#### APPEAL SUMMARY

**Status:** Decision Rendered - Reconsideration of ID 24228

<b>Appeal ID:</b> 24416	<b>Project Address:</b> 915 NE Schuyler St
<b>Hearing Date:</b> 11/25/20	<b>Appellant Name:</b> Hali Knight
<b>Case No.:</b> B-018	<b>Appellant Phone:</b> 971-352-3935
<b>Appeal Type:</b> Building	<b>Plans Examiner/Inspector:</b> Steven Mortensen, Kent Hegsted, Ed Marihart
<b>Project Type:</b> commercial	<b>Stories:</b> 9 <b>Occupancy:</b> R-2 <b>Construction Type:</b> 1-A
<b>Building/Business Name:</b>	<b>Fire Sprinklers:</b> Yes - Throughout
<b>Appeal Involves:</b> Alteration of an existing structure, Reconsideration of appeal	<b>LUR or Permit Application No.:</b> 20-185703-CO
<b>Plan Submitted Option:</b> pdf [File 1] [File 2] [File 3] [File 4] [File 5]	<b>Proposed use:</b> Residential

## DAHLKE MANOR RENOVATION

Sheet Title:  
REFLECTED CEILING  
PLAN

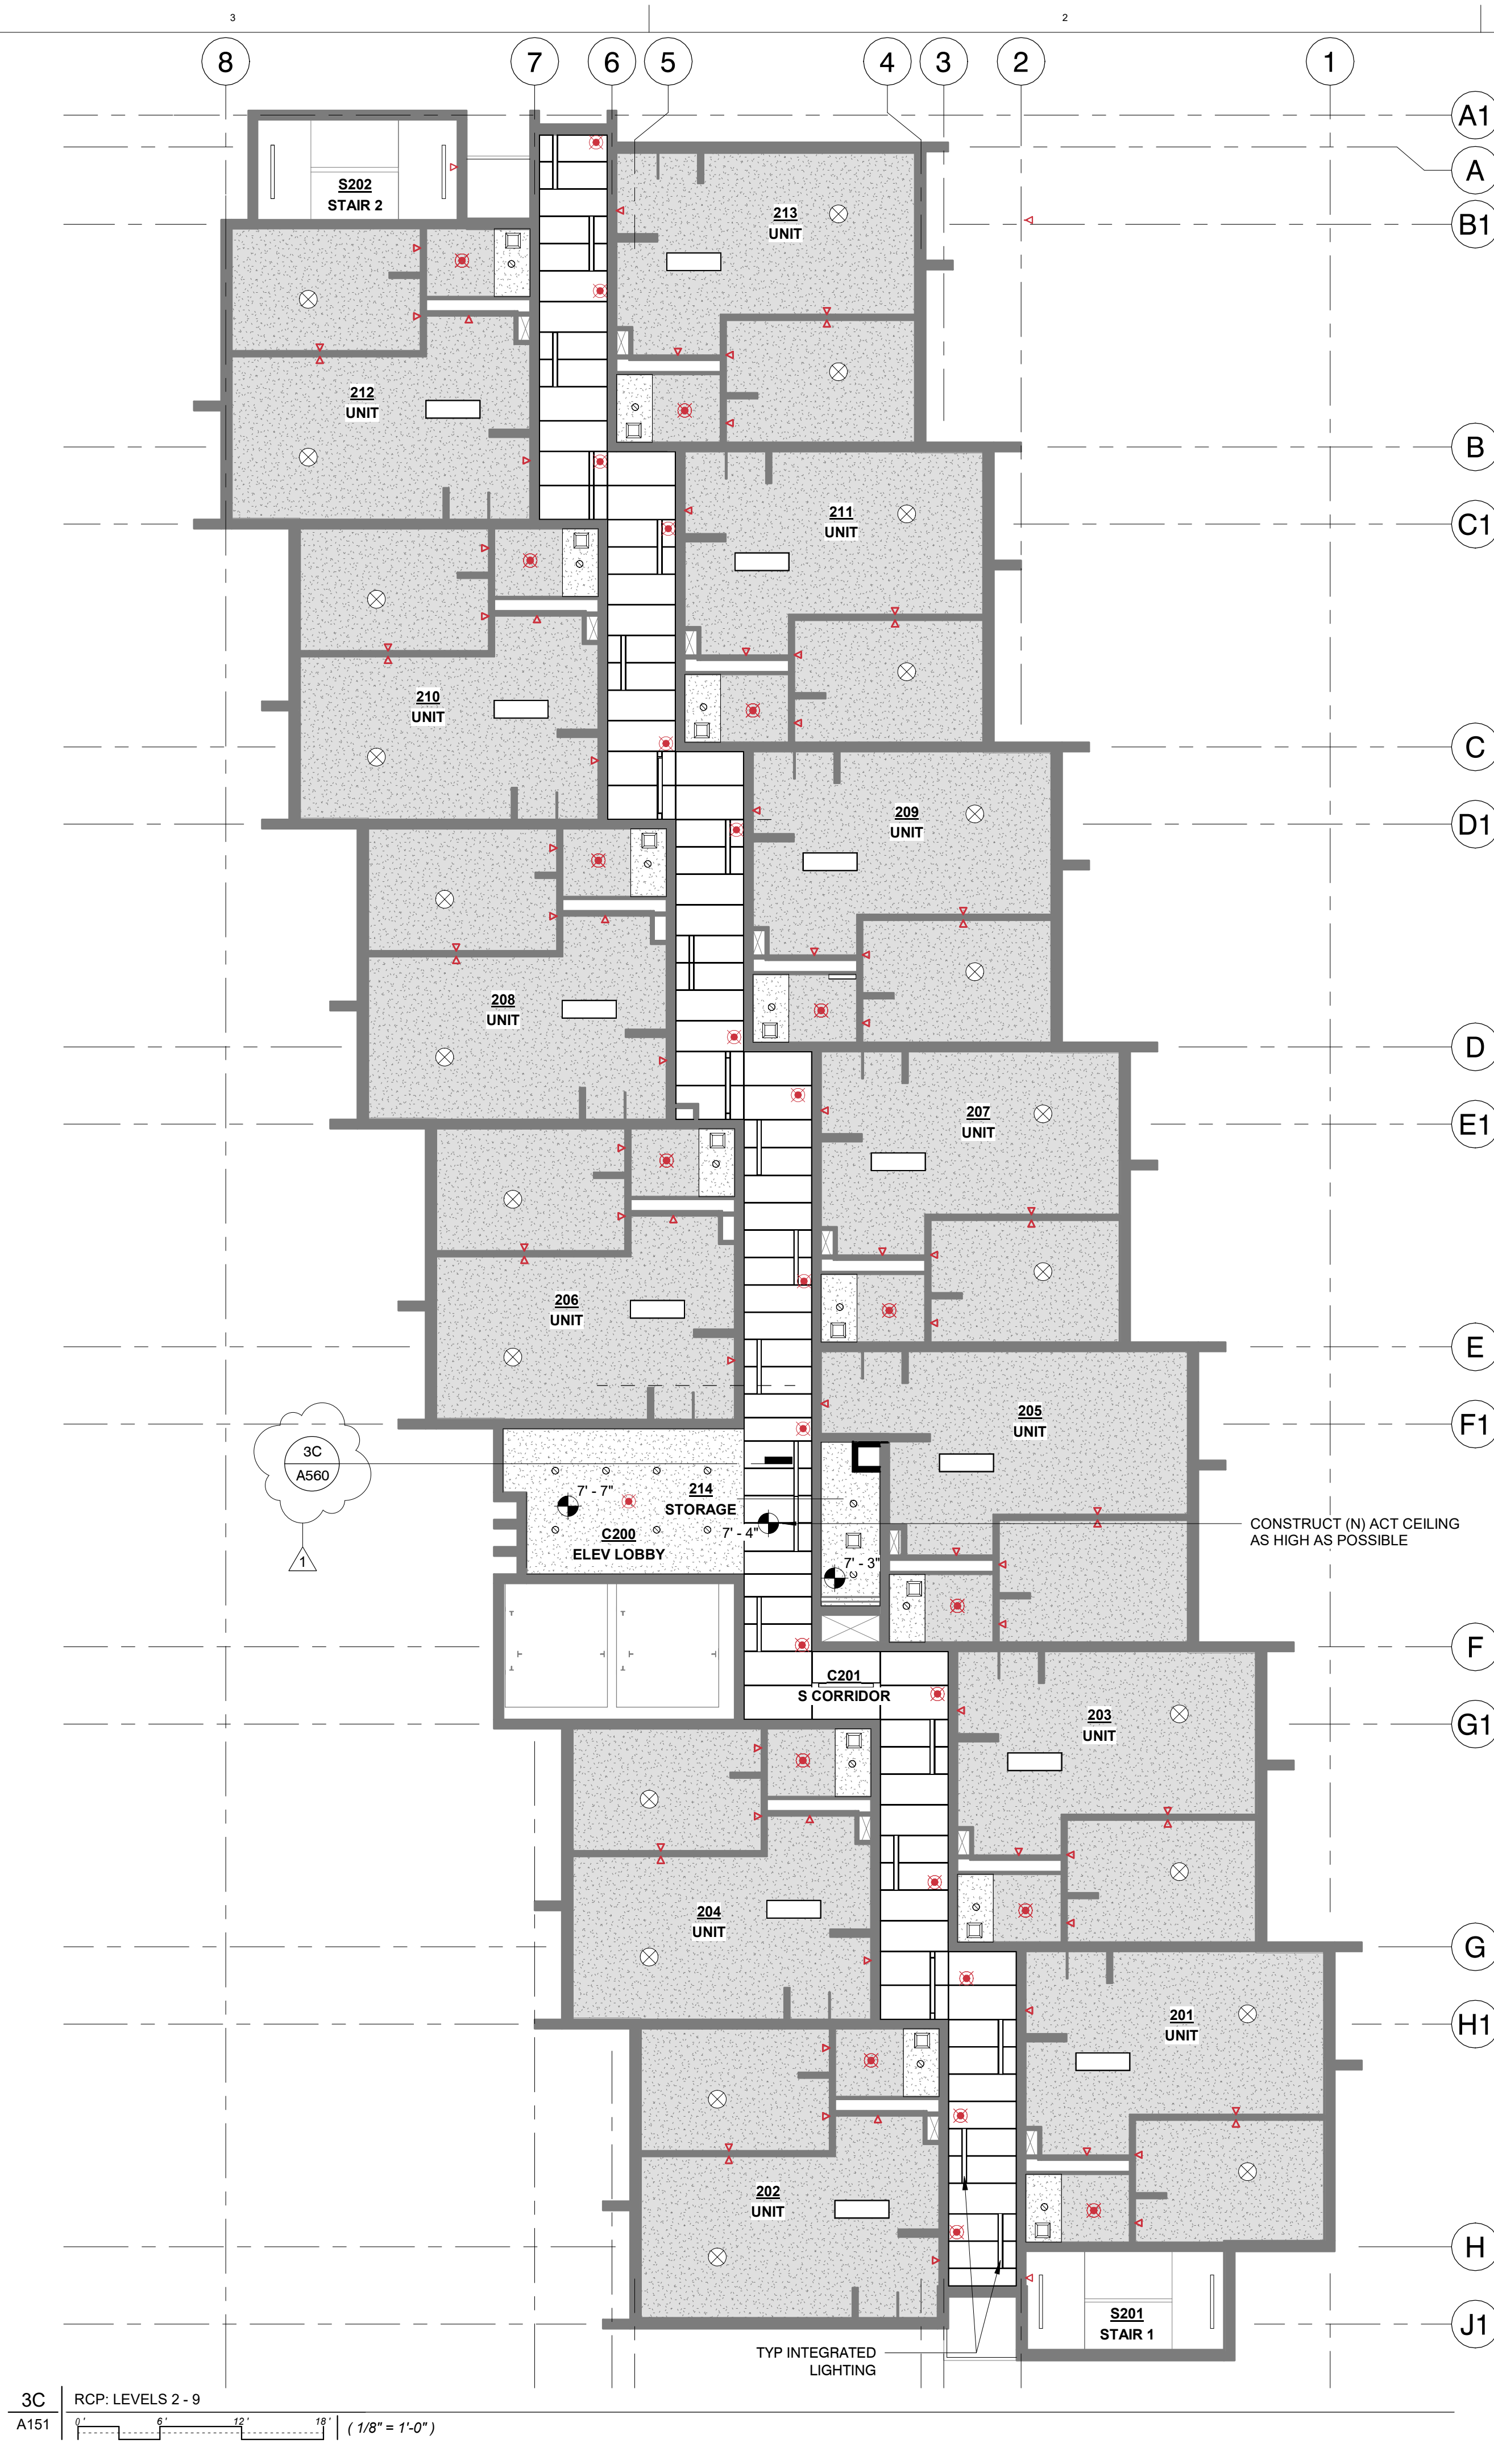
Reconsideration Text: Reference submitted sheets A150 and A151 RCP Plans that show the existing and proposed location of sprinkler heads throughout the building. Previously submitted drawings did not show all locations of existing sprinkler heads throughout the building, only those in scope for new work. The scope of work will replace existing sprinkler heads and add new sprinklers in common areas and the new addition. The building will be fully sprinklered throughout and meets NFPA 13.

Reconsideration Text: Reference submitted sheets A150 and A151 RCP Plans that show the existing and proposed location of sprinkler heads throughout the building. Previously submitted drawings did not show all locations of existing sprinkler heads throughout the building, only those in scope for new work. The scope of work will replace existing sprinkler heads and add new sprinklers in common areas and the new addition. The building will be fully sprinklered throughout and meets NFPA 13.

Reconsideration Text: Reference submitted sheets A150 and A151 RCP Plans that show the existing and proposed location of sprinkler heads throughout the building. Each unit is fully sprinklered with 6-7 sprinkler heads and meets NFPA 13.

**1. Alterations to Chapter 13 building: Granted provided Life Safety check sheet items are satisfactorily addressed prior to approval of life safety plan review.**
